Variance Petition No. V09-028

Prepared by the City of Sandy Springs Department of Community Development for the Board of Appeals Hearing on October 8, 2009

1100 Hope Road

V090028

NEW LAYOUT
PARKING VARIANCE

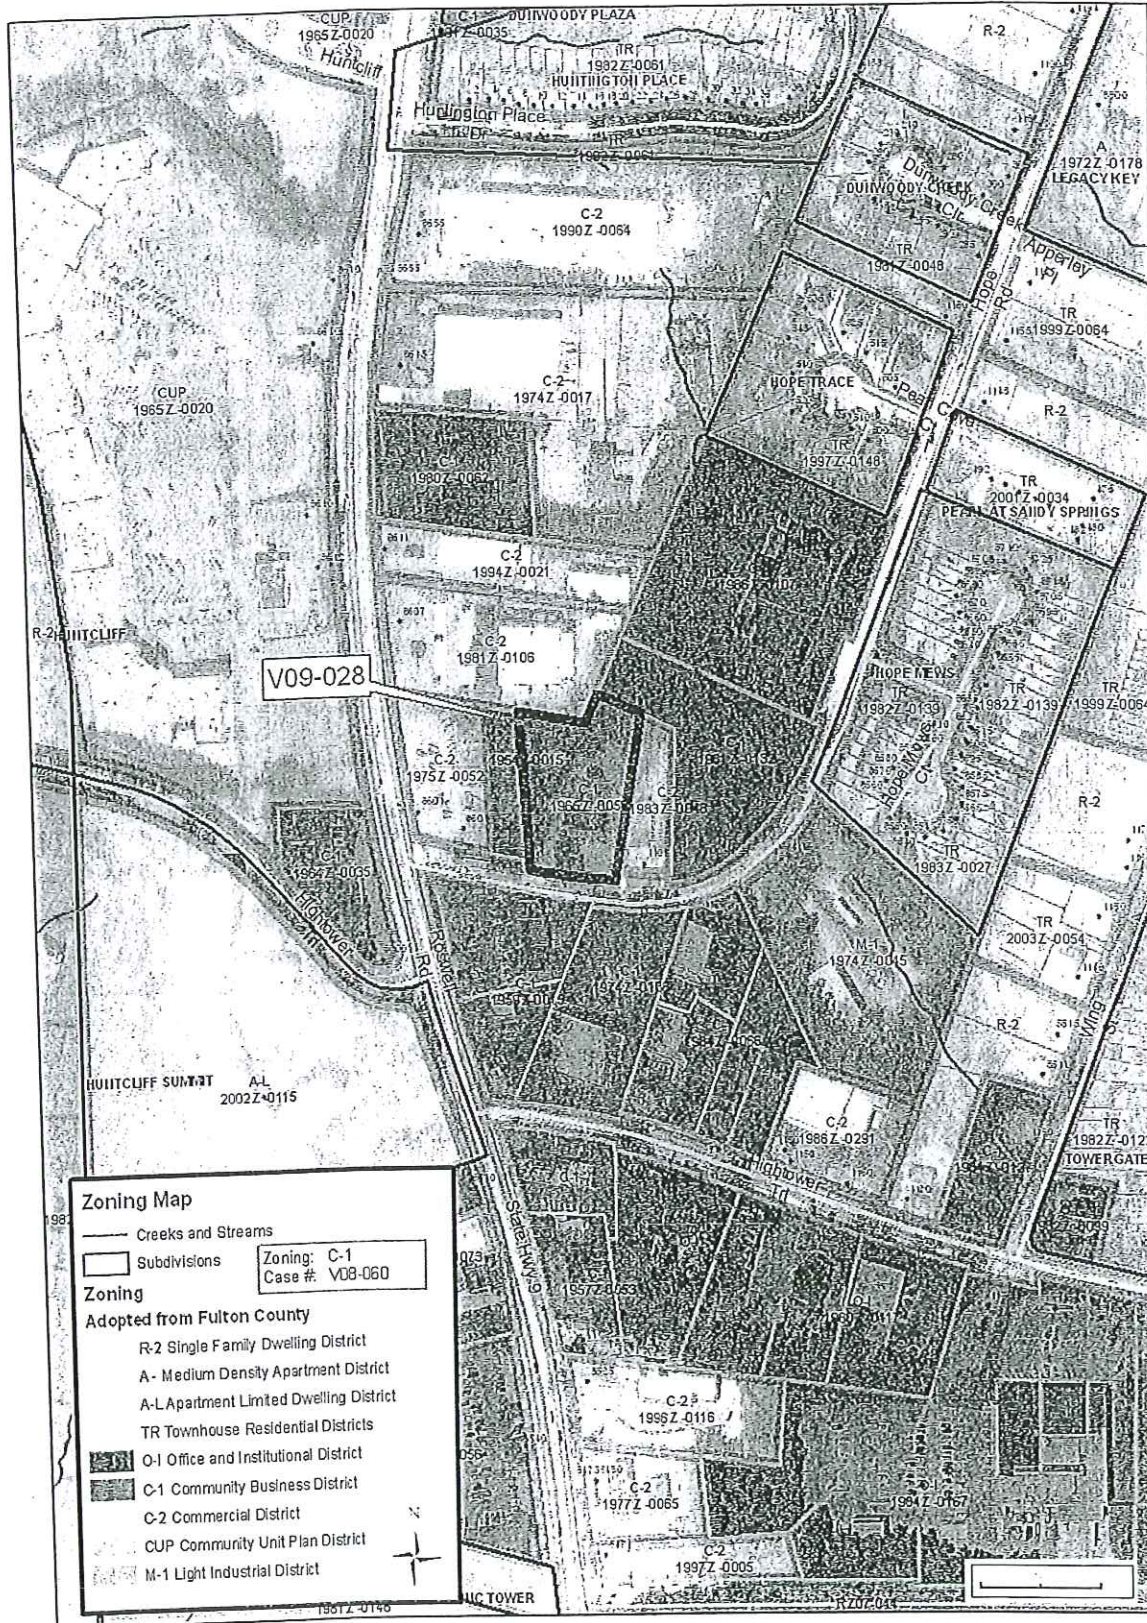
The applicant is requesting five (5) primary variances from the Zoning Ordinance:

- 1) Variance from Section 4.23.1.A of the Zoning Ordinance to reduce the required 10 foot front landscape strip to one (1) foot and the 5 foot side landscape strip to zero (0) feet.

- 2) Variance from Section 4.23.2 of the Zoning Ordinance to allow for a parking lot without the required parking islands.
- 3) Variance from Section 18.2.1 of the Zoning Ordinance to reduce the required parking spaces from 57 to 42.

NEW LAYOUT
PARKING VARIANCE

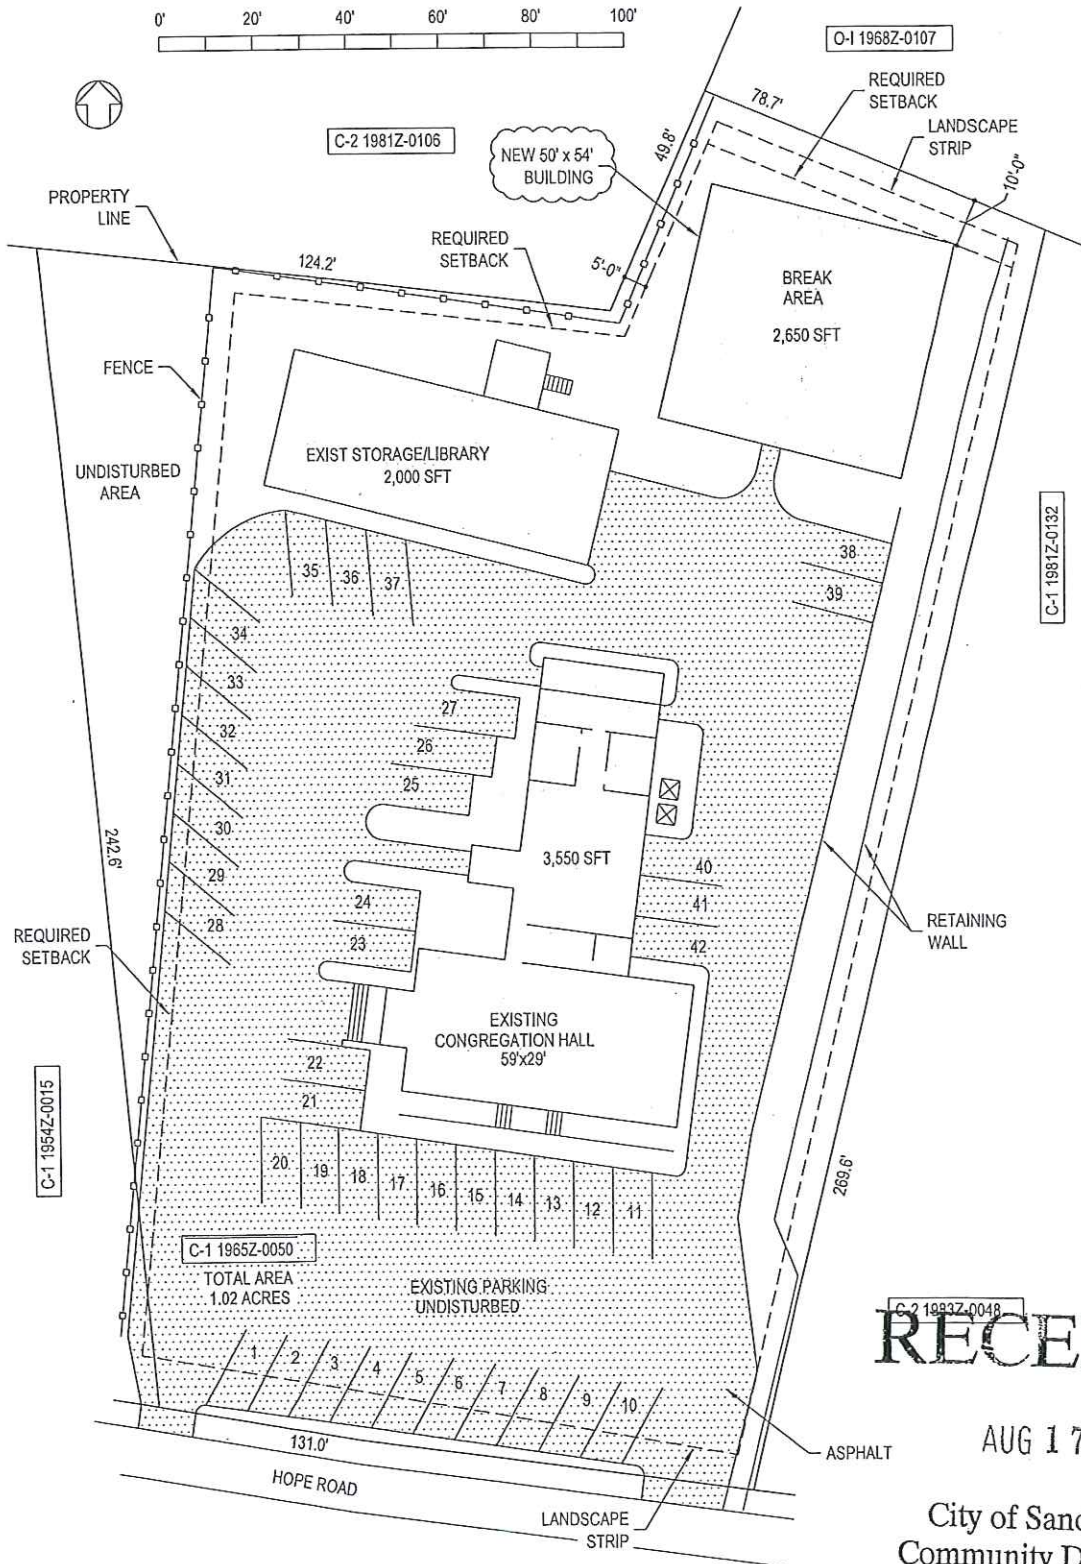
BUILDING AND DEVELOPMENT	Engineering Plan Reviewer	<ul style="list-style-type: none"> No comments
	Arborist/Landscape Architect	<ul style="list-style-type: none"> There is one 28" +/- pine tree in the front that will need to be protected. It doesn't appear that the site meets the minimum canopy requirements.
	Building Plan Reviewer	<ul style="list-style-type: none"> No comments
FIRE DEPT.	Fire Protection Engineer	<ul style="list-style-type: none"> Section 3.3.1 of the City of Sandy Springs Fire Ordinance requires that every existing building and all new buildings shall be accessible to fire department apparatus by way of designated fire lanes with an all-weather driving surface of not less than 20 feet of unobstructed width. There shall be a minimum roadway outside turning radius at the curb of 40 feet. There shall be a minimum vertical clearance of thirteen feet, six inches (13'6"). Any dead-end fire department access roadway in excess of 150 feet in length shall include a turnaround at the closed end conforming to county construction standards and specifications, latest edition. Refer to 120-3-3, modification to the 2003 IFC, "508.5.1 Where required. Where a portion of the facility or building hereafter constructed or moved into or within the jurisdiction is more than 500 feet (152 m) from a hydrant on a fire apparatus access road, as measured by an approved route around the exterior of the facility or building, on-site fire hydrant mains shall be provided where required by the local responding fire department or agency. "Exceptions: "1. For group R-3 and Group U occupancies, the distance requirement shall be 600 feet (183 m). "2. For buildings equipped throughout with an approved automatic sprinkler system installed in accordance with Section 903.3.1.1 or 903.3.1.2, the distance requirement shall be 600 feet (183 m)." <p>Fire hydrants may not be omitted unless written approval by the local responding fire department or agency is submitted to this office.</p>

1. The lot shall be in accordance with the site plan, provided by the applicant dated received August 17, 2009 by the Department of Community Development, for the variance(s) herein, showing a 3,550 square foot existing congregation hall with a 1,711 square foot assembly area, a 2,000 square foot existing library/ storage area, a 2,650 square foot break area.

- a. To reduce the required number of parking spaces from 57 to 42.
 - b. To reduce the required 10 foot front landscape strip to one (1) foot and the 5 foot side landscape strip to zero (0) feet.

- c. To eliminate the required parking lot landscape islands every 6th space.
 - d. To allow a permanent structure (parking lot) within a landscape strip.

- e. To allow for the reconfiguration and expansion of an existing nonconforming parking lot.
2. The lot shall be in accordance with the Landscape plan, provided by the City Arborist dated received October 8, 2009 by the Department of Community Development.

- a. That the eliminated thirteen 3" parking lot shade trees be installed on the site to provide shade to the proposed parking as per a landscape plan approved by the city arborist.

- b. The reduced landscape strip along Hope Road should be planted to meet landscape strip requirements as per a plan approved by the city arborist.
